To: Matt LeGrant, Zoning Administrator

Re: 100 V Street SW, Square 609 and 611

TO: Matthew Le Grant  
FROM: Norman M. Glasgow, Jr.  
DATE: May 22, 2020  
RE: 100 V Street, SW

# T STREET SW BHMP

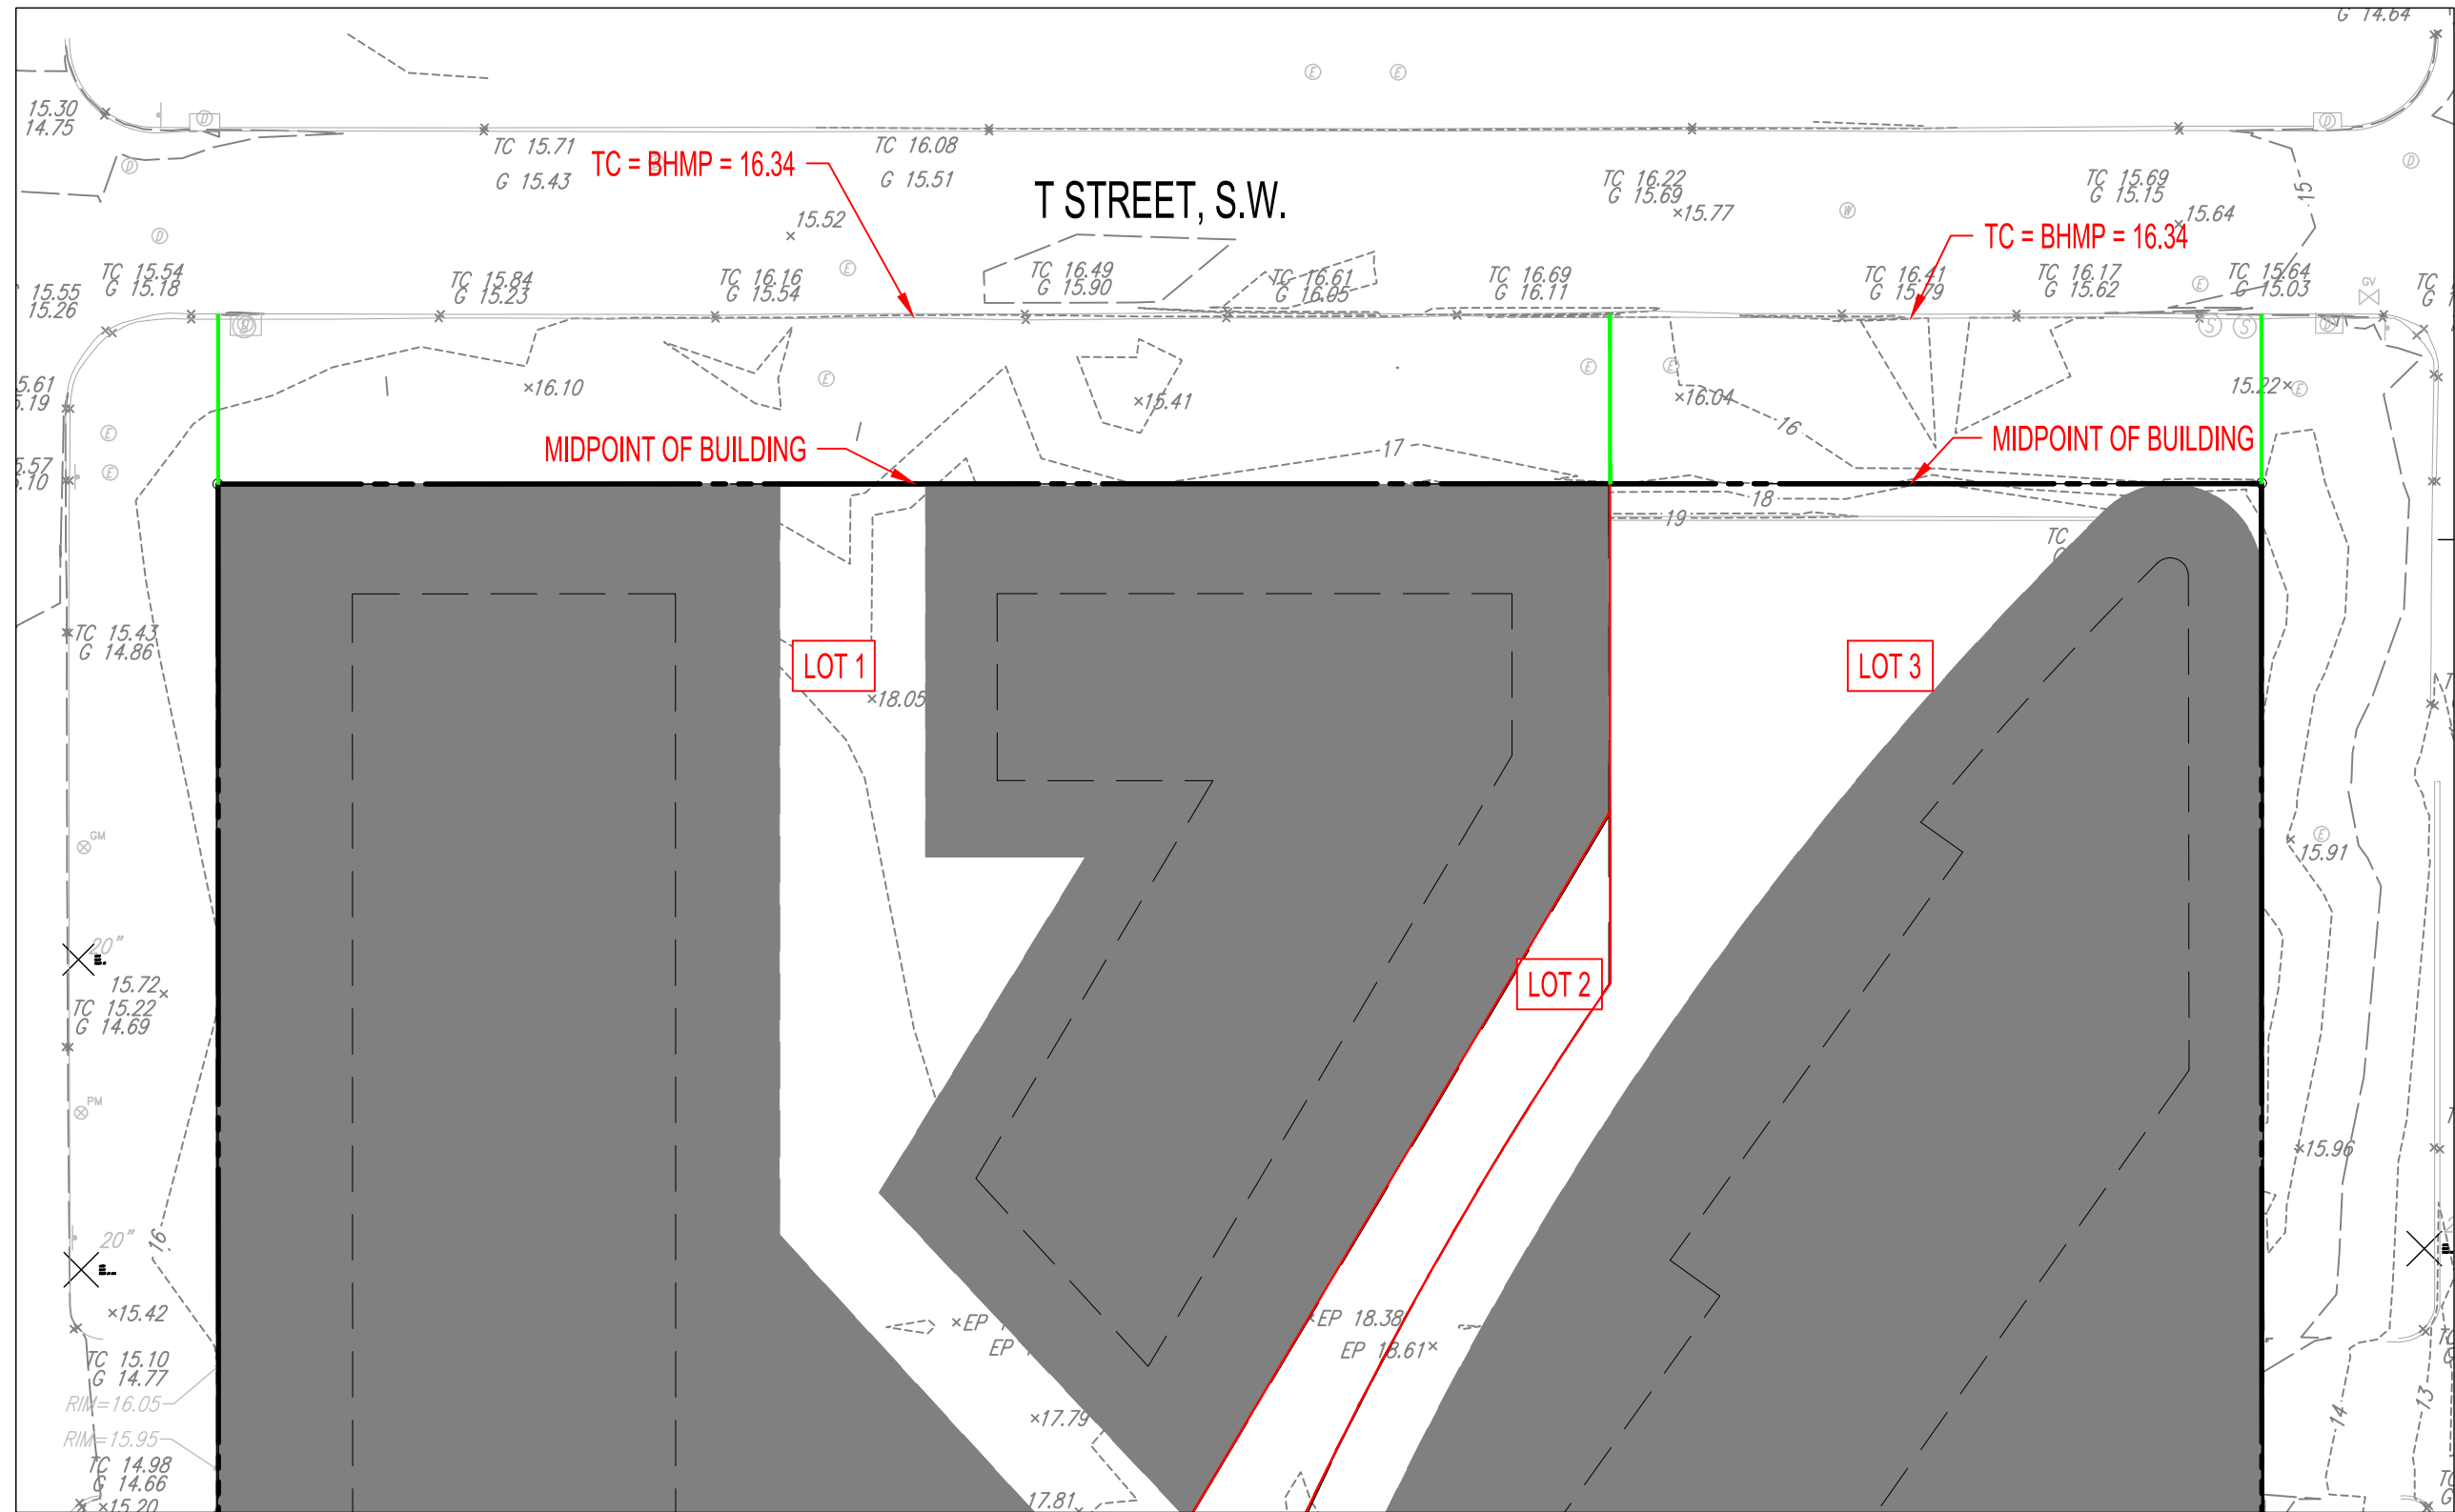
First, the location of the Building Height Measuring Point (“BHMP”) for two buildings that front on T Street, SW. As shown on Attachment A, one building is located on Lot 1 and one building is located on Lot 2. While both buildings have frontage on T Street, they have setbacks of varying degrees from the T Street property line. The building footprints are shown in gray, with the lot lines, the top of curb (TC) and BHMP elevations, and the midpoint of each building shown in red. The green markings show the extent of the frontage of each building along T Street. As shown on Attachment A:

- The midpoint of the Lot 1 building (which two components constitute a single building for zoning purposes) and the BHMP at the top of the curb is shown at elevation 16.34, as shown on the west side of the site (left hand side of the image); and
- The midpoint of the Lot 3 building and the BHMP at the top of the curb is also shown at elevation 16.34, as shown on the east side of the site (right hand side of the image).

In addition, we discussed that there may be a curb cut on Lot 1 where the middle of the front of the building would be located, in which case there would be no “top of curb” in that precise location. In that event, we discussed that the applicant would take the curb elevations on either side of the curb cut, and the BHMP would be taken where the line between the curb cuts and the middle of the building intersect at an elevation as if the curb were there.

# **ATTACHMENT B**

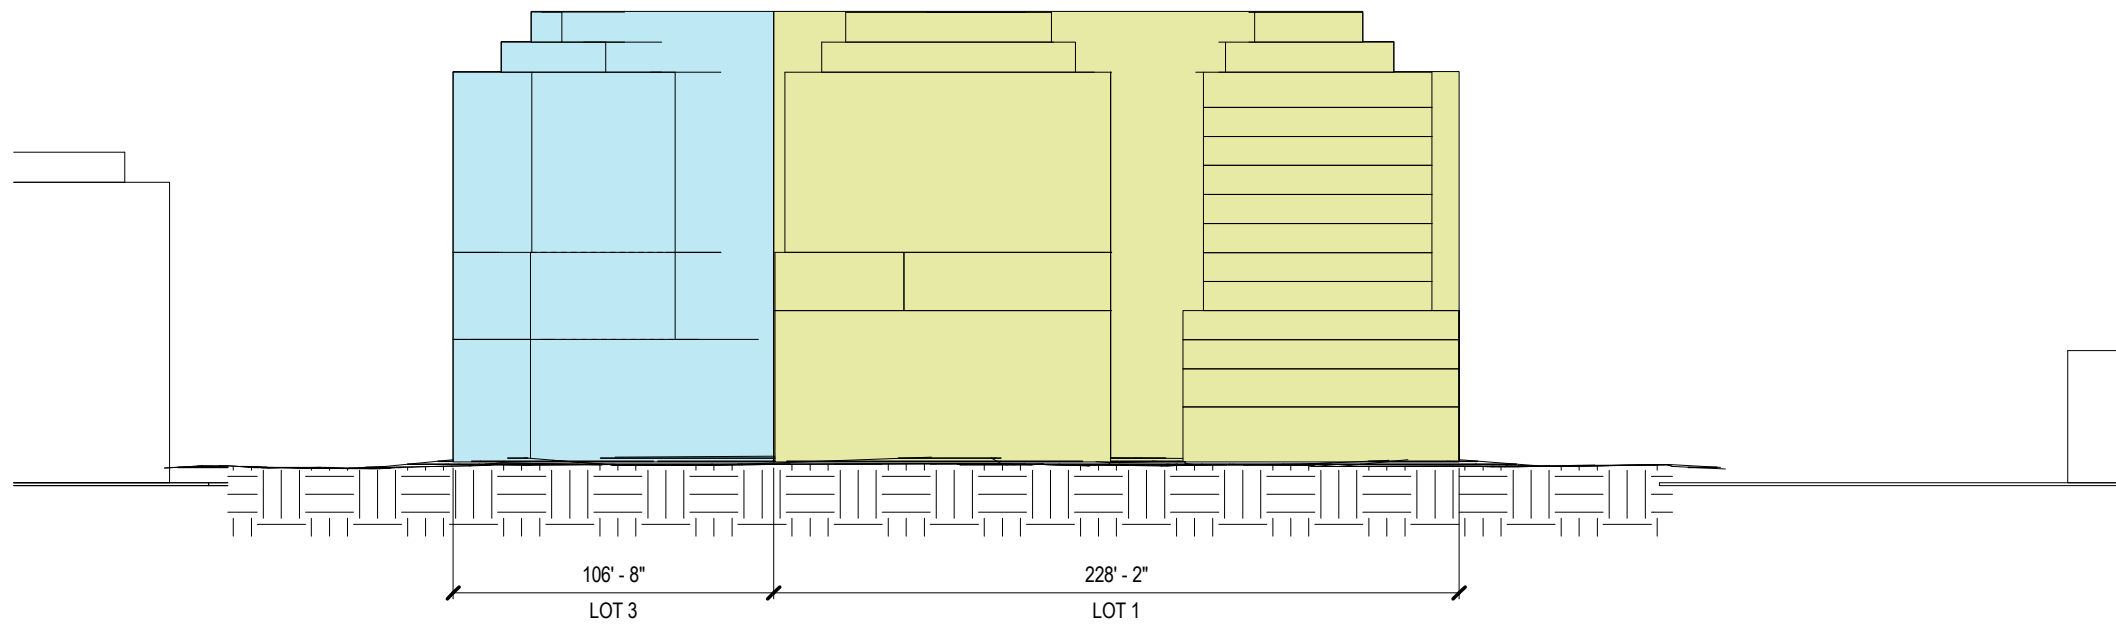
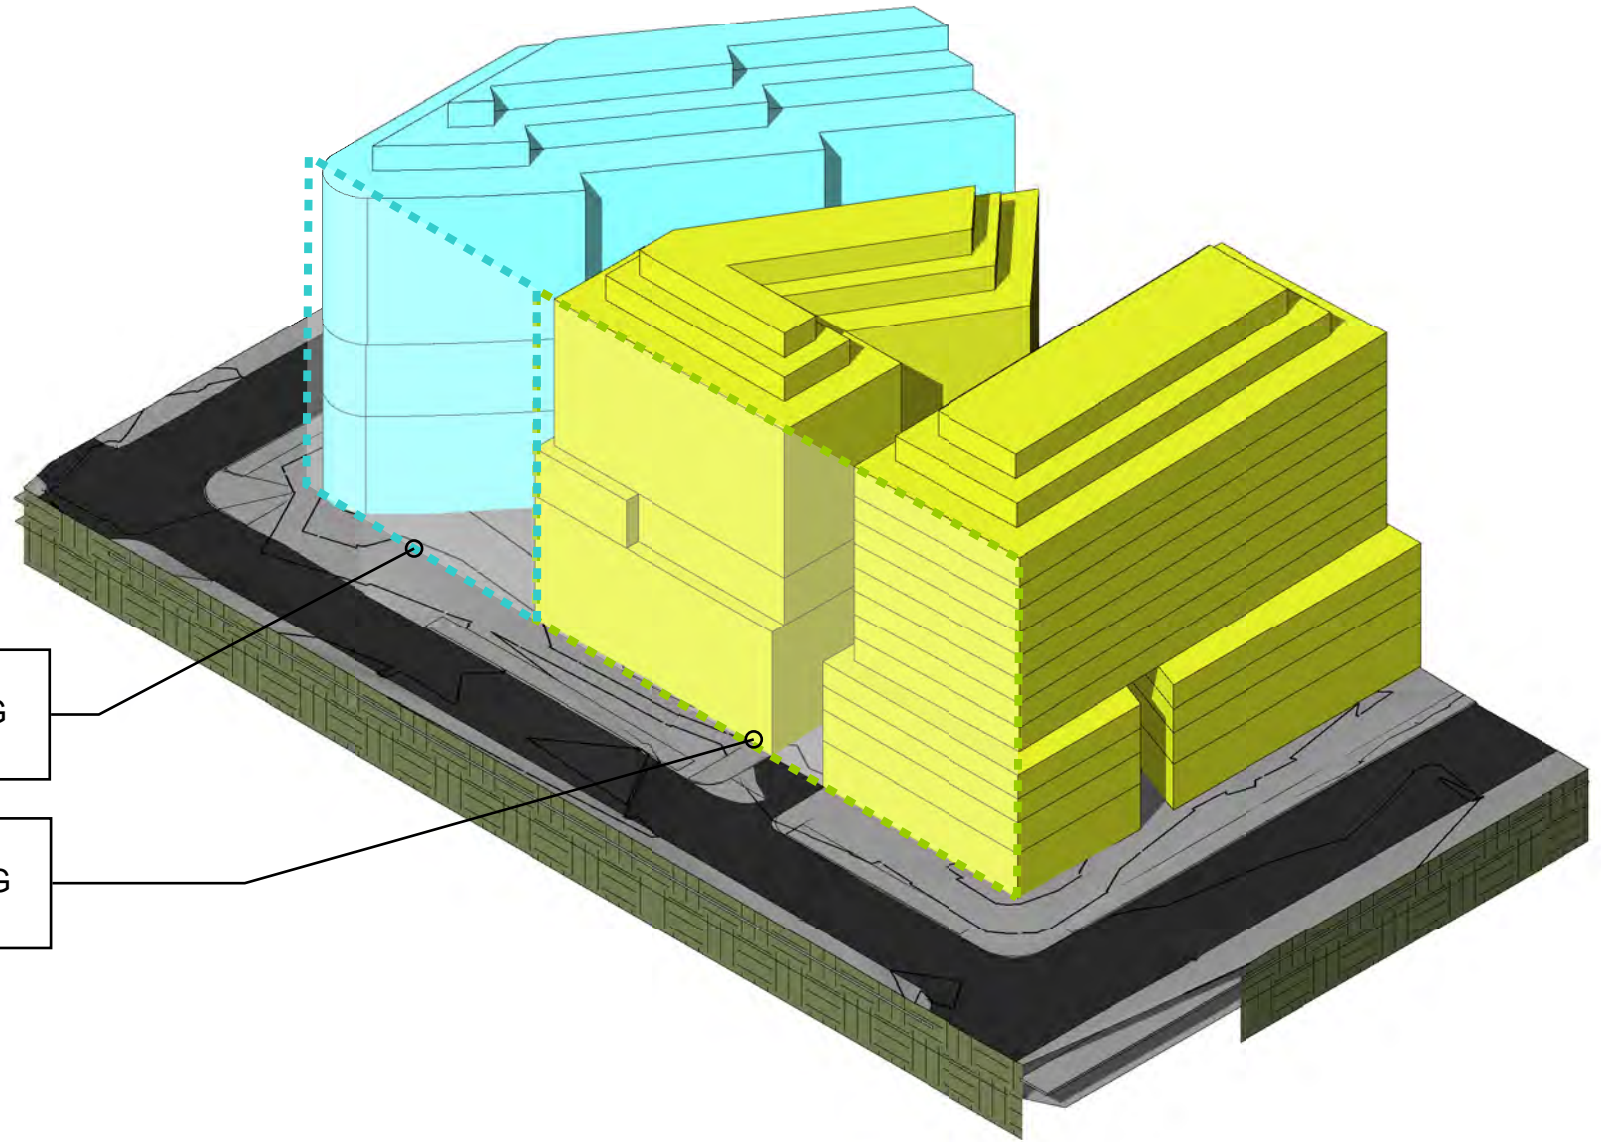
Attachment B includes images from an elevation perspective that show the buildings located on Lot 1 and Lot 3.

LOT 3  
MIDPOINT OF BUILDING  
BHMP = 16.34

LOT 1  
MIDPOINT OF BUILDING  
BHMP = 16.34
